FINAL PLAT OF
"ROONEYS' FIRST ADDITION"
SEDGWICK COUNTY, KANSAS
IN THE NE 1/4 OF SECTION 17, T29S, R1W OF THE 6TH P.M.

RE: S/D 00-18 -- One-Step Final Plat of ROONEYS' FIRST ADDITION

STAFF REPORT
(One-Step Final Plat)

CASE NUMBER: S/D 00-18 -- ROONEYS' FIRST ADDITION

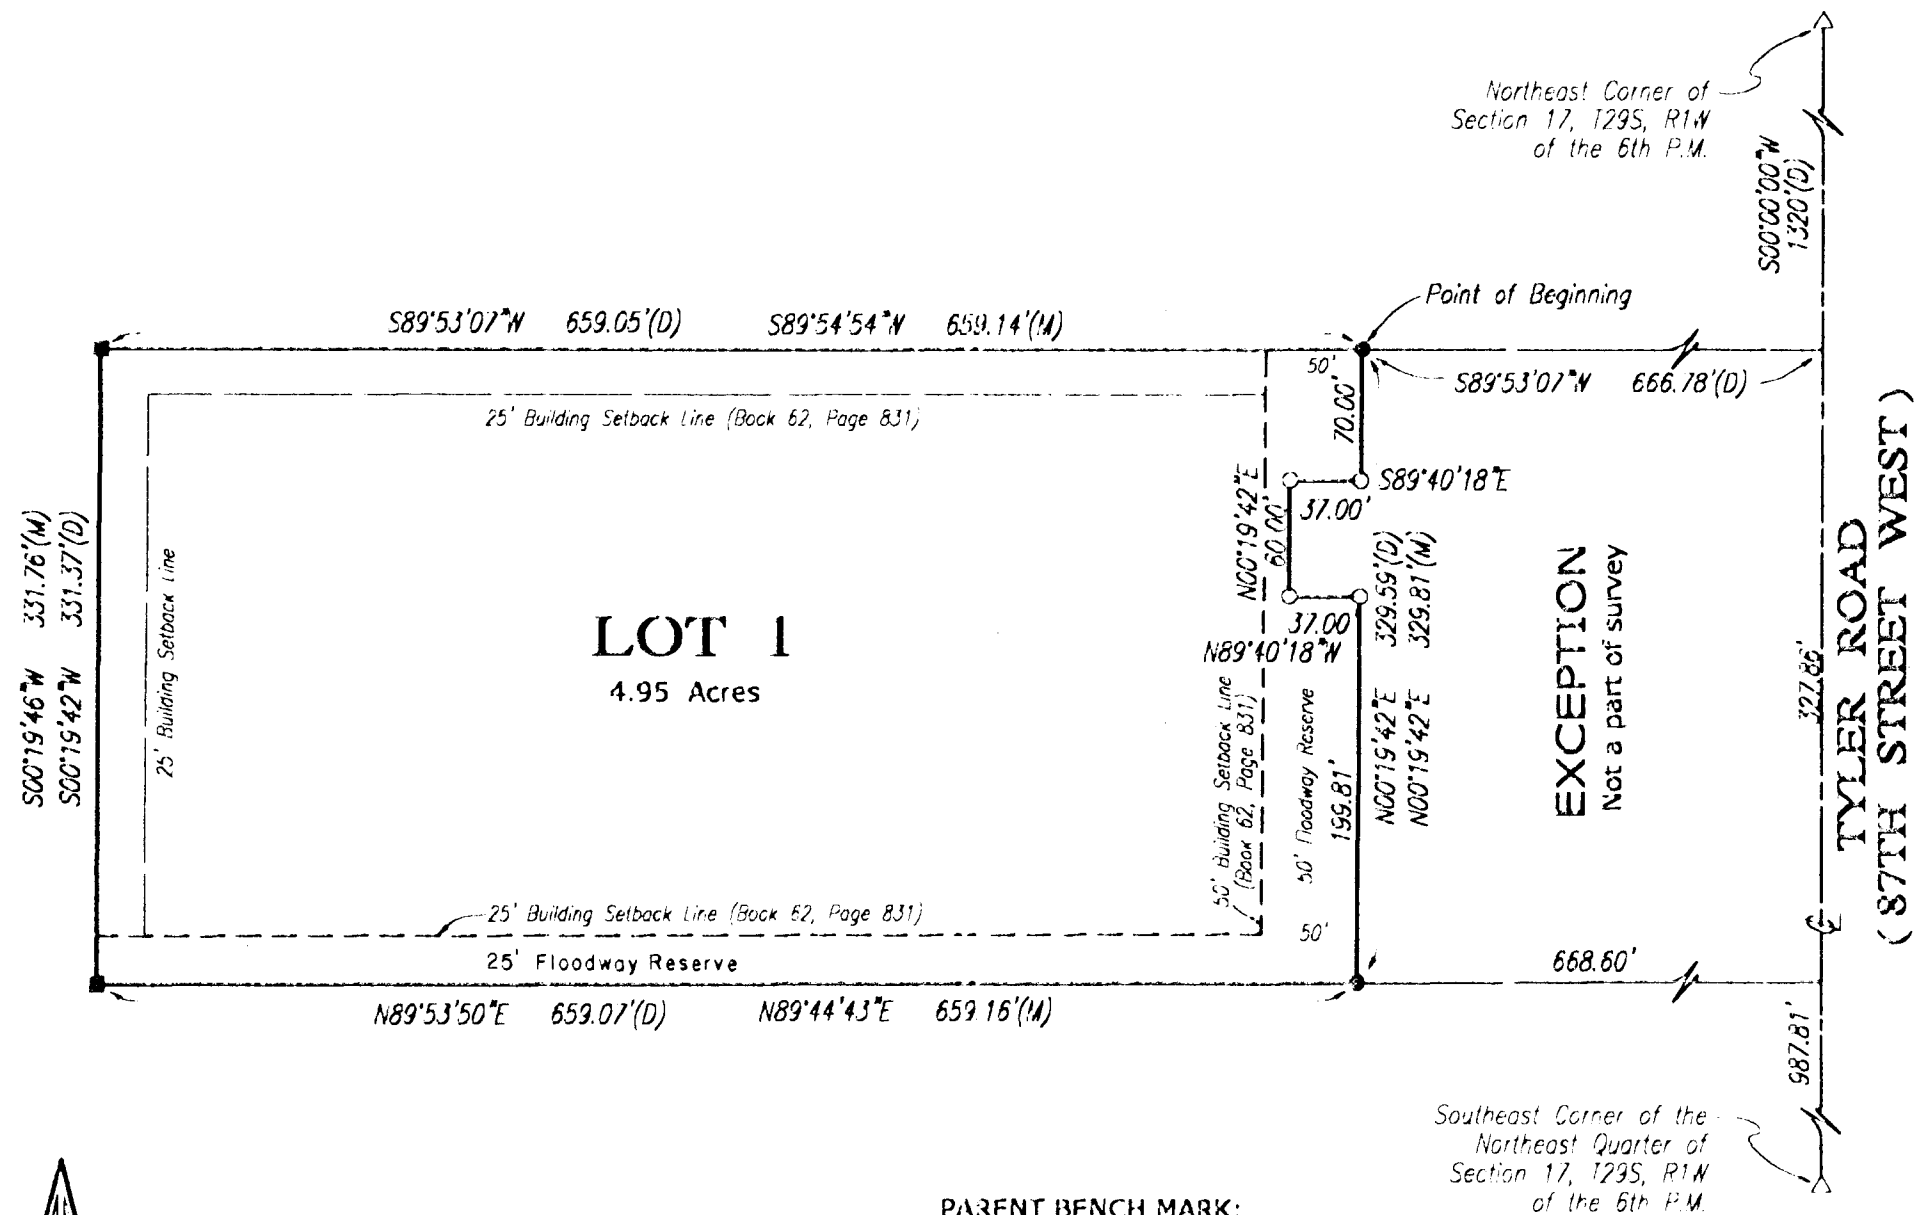
- C. **County Engineering** needs to comment on the status of the applicant's drainage plan. **The drainage plan is approved. A Floodway Reserve is required along the south lot line and on the east lot line.**

- D. **County Engineering** and **County Fire Department** needs to comment on the access to this property. The plat proposes access through an existing 50-ft private street which currently serves three lots. The Subdivision regulations limit private streets to serving no more than three lots. Approval of the proposed plat would require a modification from the Subdivision regulations. An ingress/egress easement needs to be established by separate instrument which includes this lot. **County Fire Department has approved the site for a 24' wide access road. The Subdivision Committee have the approved the access road for four total lots.**

- E. The platlor's text shall note the creation of the floodway reserve in addition to referencing the standard floodway language.
- F. For those reserves being platted for floodway purposes, the required covenant which provides for ownership and maintenance of the reserves shall grant, to the appropriate governing body, the authority to maintain the reserves in the event the owner fails to do so. The covenant shall provide for the cost of such maintenance to be charged back to the owner by the governing body.

- C. County Engineering needs to comment on the status of the applicant's drainage plan. *A Floodway Reserve is required along the south lot line and on the east lot line.*

- D. County Engineering and County Fire Department needs to comment on the access to this property. The plat proposes access through an existing 50-ft private street which currently serves three lots. The Subdivision regulations limit private streets to serving no more than three lots. Approval of the proposed plat would require a modification from the Subdivision regulations. An ingress/egress easement needs to be established by separate instrument which includes this lot.
